**ARCHITECT'S SUPPLEMENTAL INSTRUCTIONS**

JONES GILLAM RENZ DOCUMENT JGR 710

<b>PROJECT:</b>	The Reserves at Grand View Heights New Development Laramie, Wyoming	<b>Report No.</b>	Eight (8)
<b>OWNER:</b>	Overland Property Group Dan Maximuk 250 N. Santa Fe Ave, Suite A Salina, KS 67401	<b>Date</b>	April 22, 2025
<b>CONTRACTOR:</b>	Overland Construction Group 250 N. Santa Fe Ave, Suite A Salina, KS 67401	<b>Architect's Proj No.</b>	22-3262
		<b>Contract For:</b>	General Construction Mechanical, Electrical

DATE: 7-17-2024  
JOB: 22-3262  
SHEET NO.:

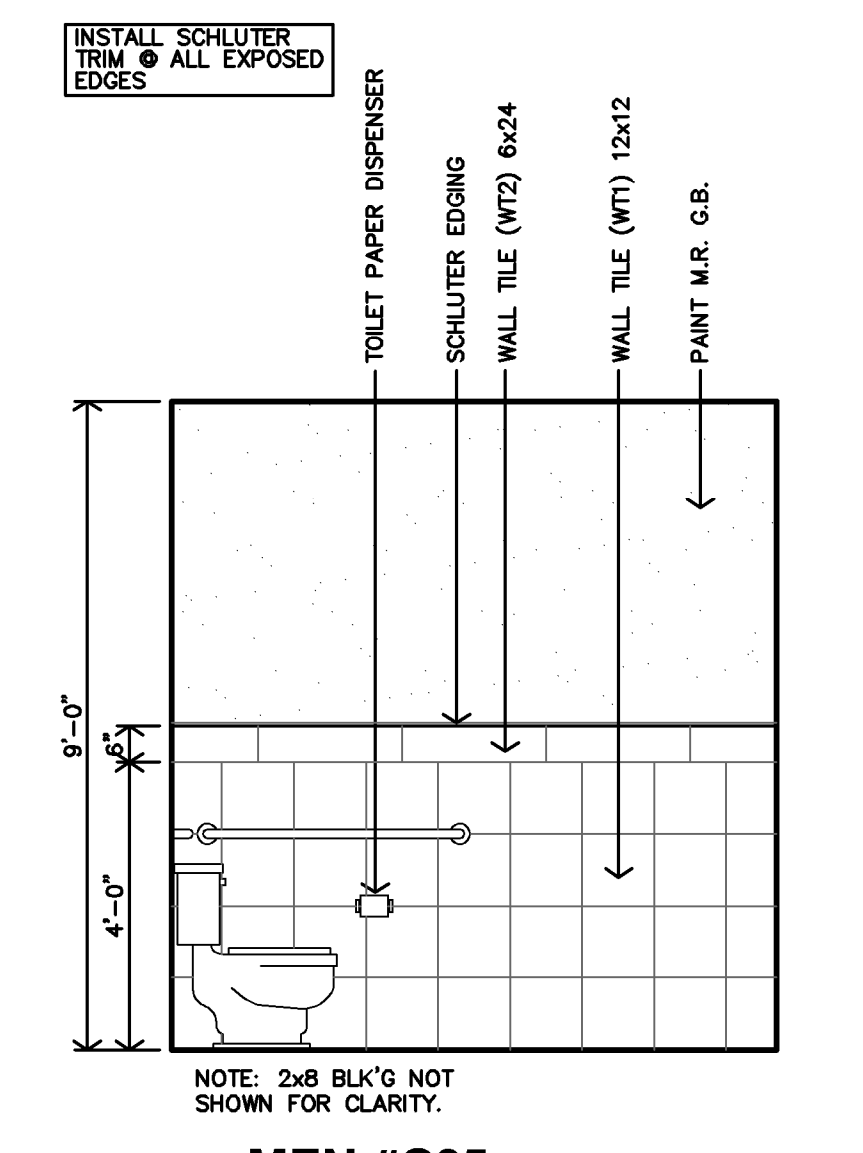
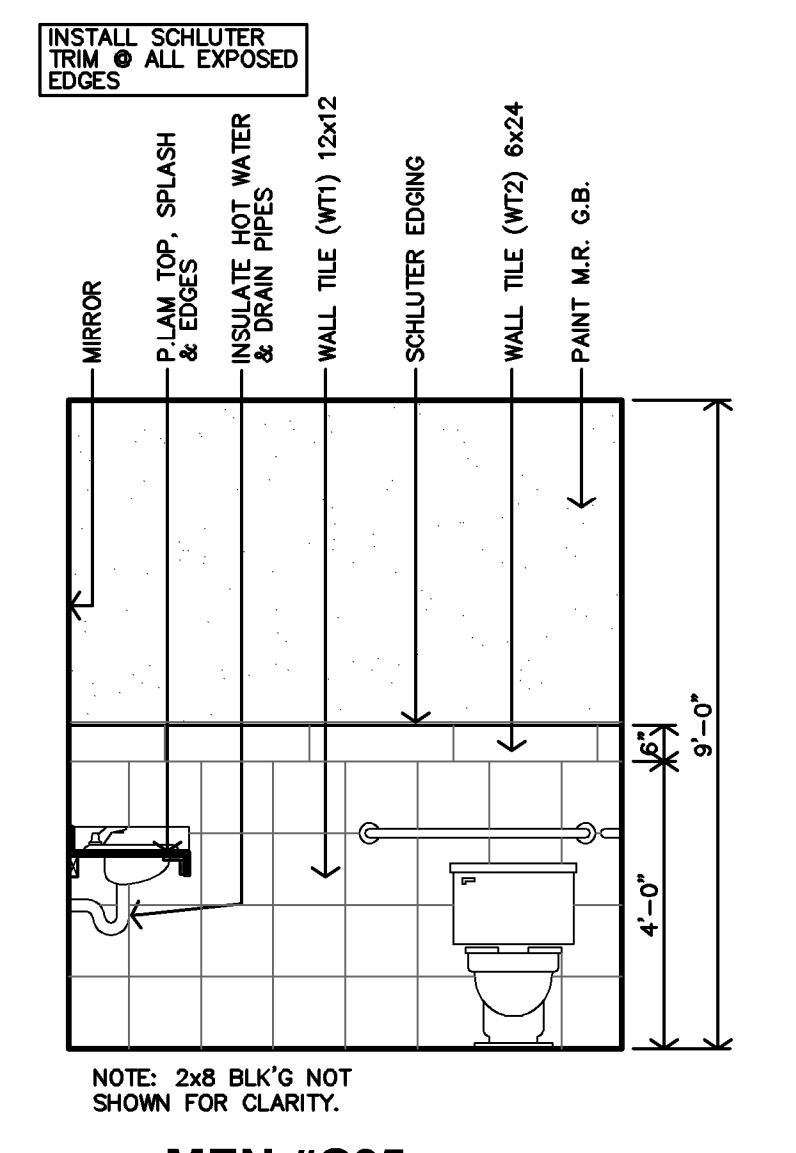
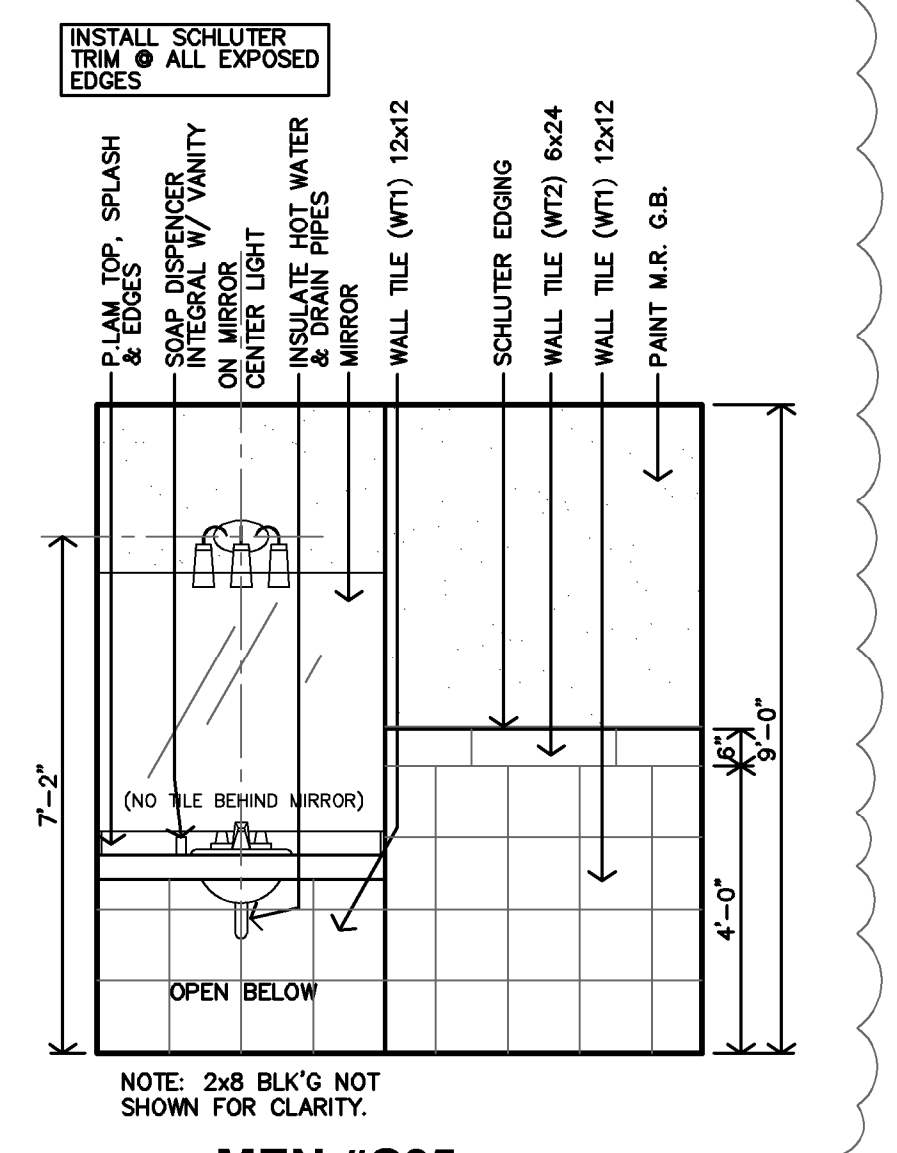
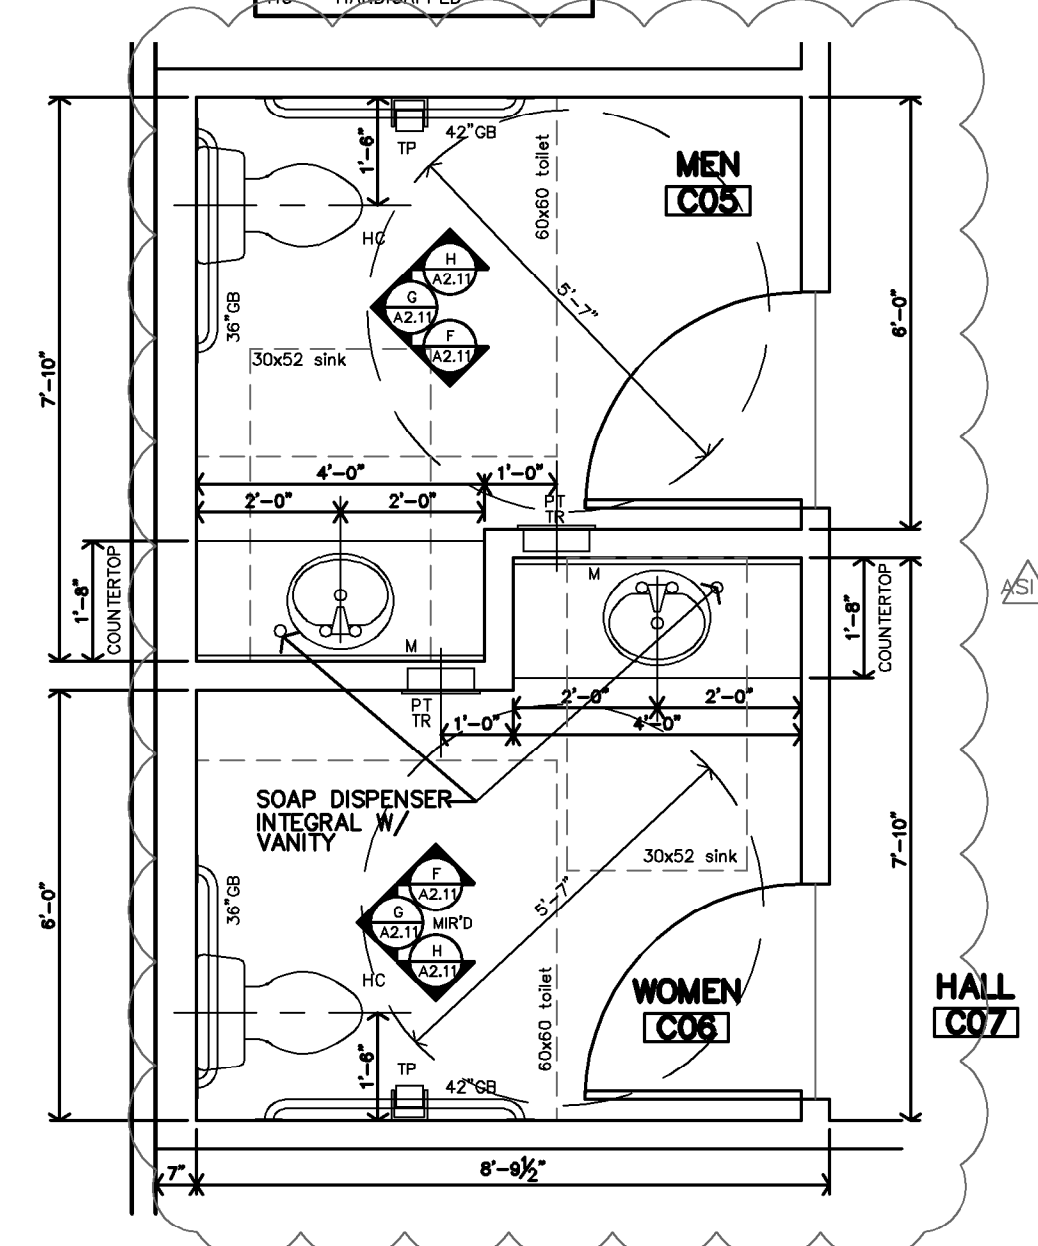
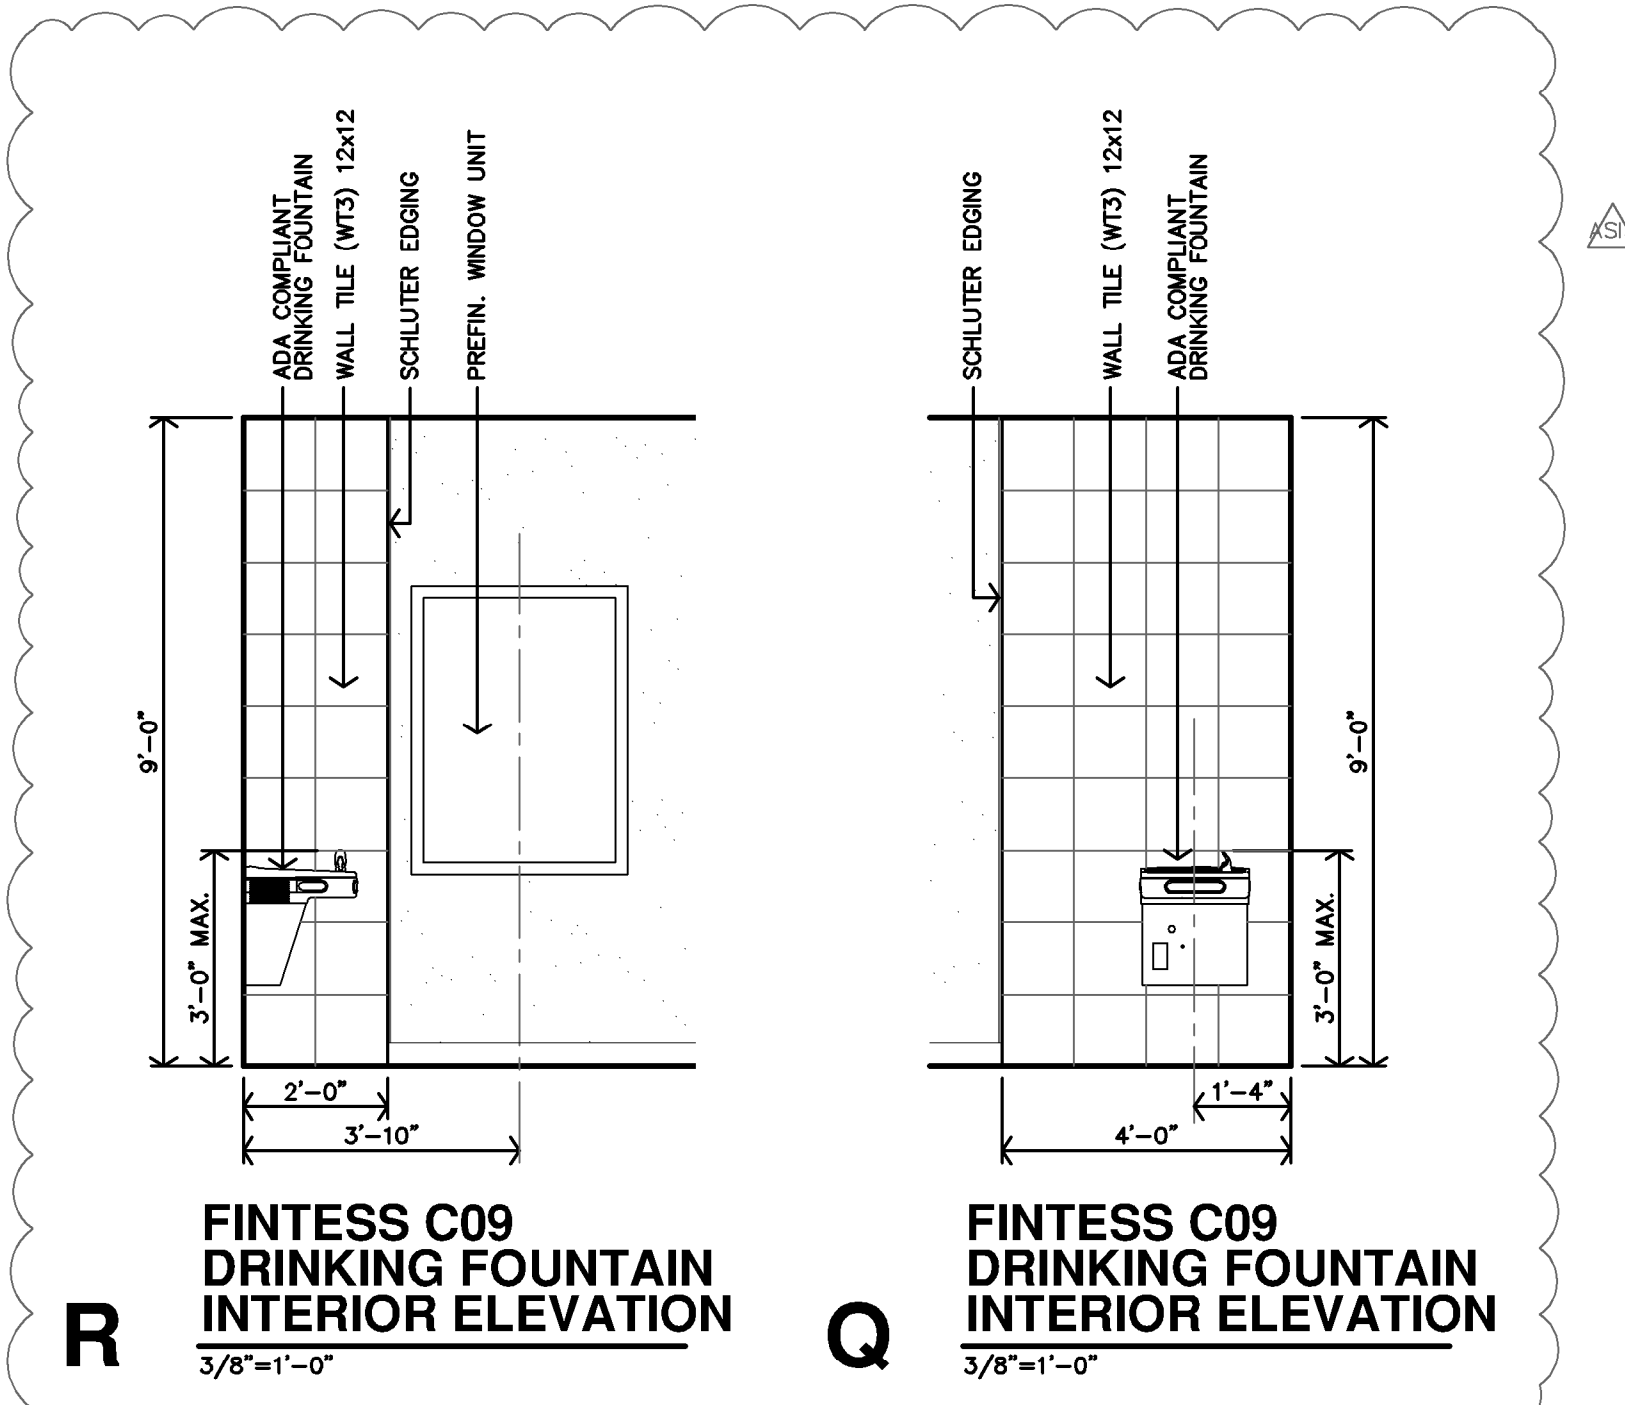
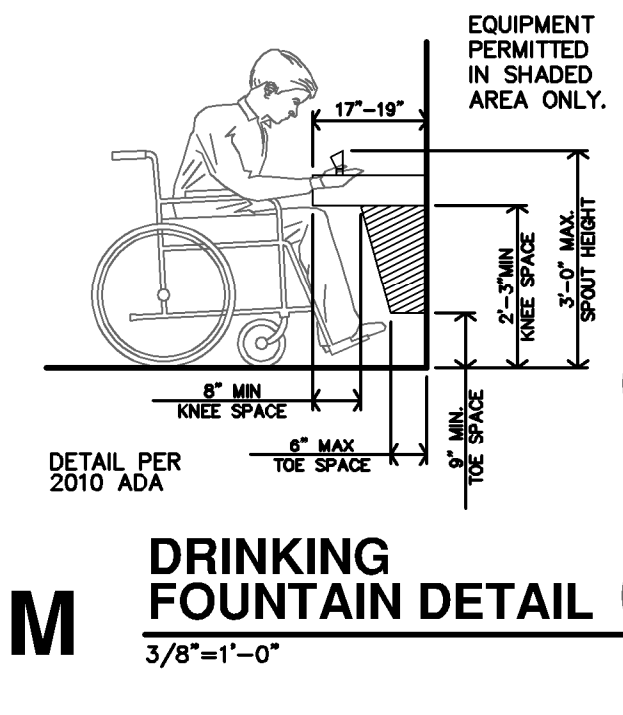
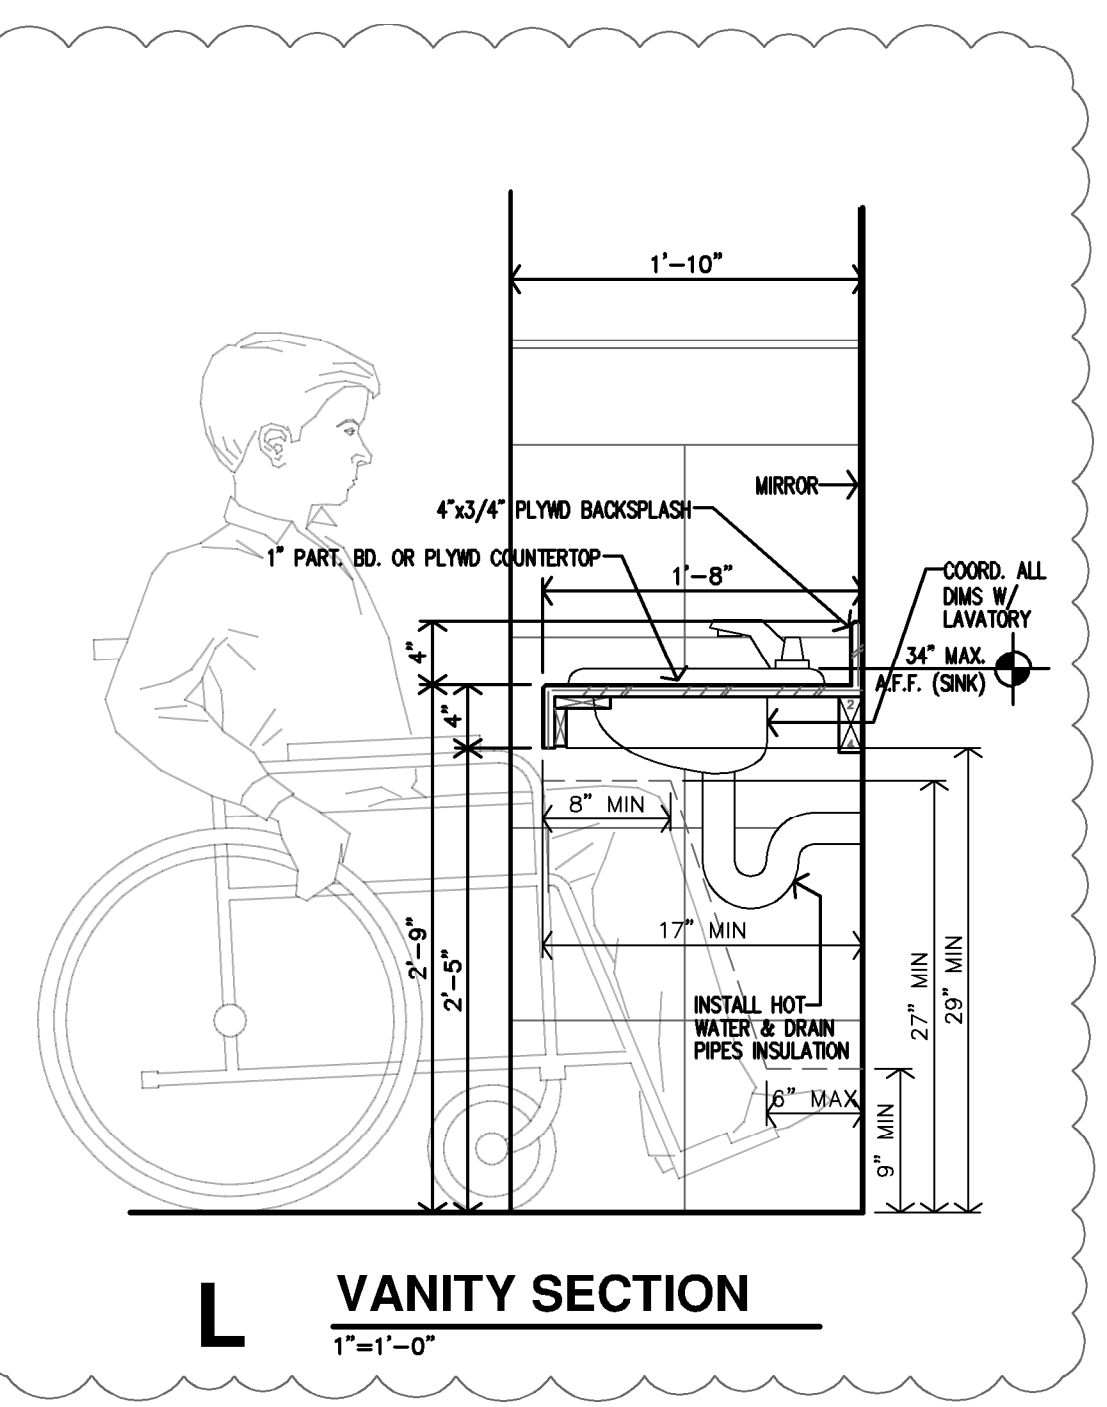
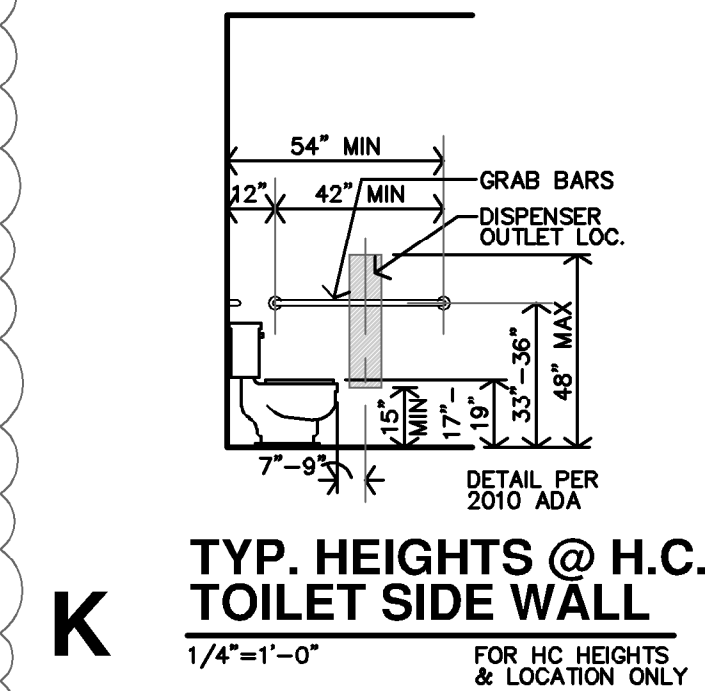
- 1) Sheet A2.11
  - o Detail A – Kitchen sink to have roll-under approach. Cabinet below sink has been removed. Add divider next to dishwasher.
  - o Detail P – Added detail. Add 6" screen below countertop.
- 2) Sheet ME – added ceiling radiation dampers to main supply duct and mech room diffuser
- 3) Sheet P1.1 – revised kitchen sink & lavatory B107
- 4) Sheet P1.3 – revised kitchen sinks in A101 and A102.
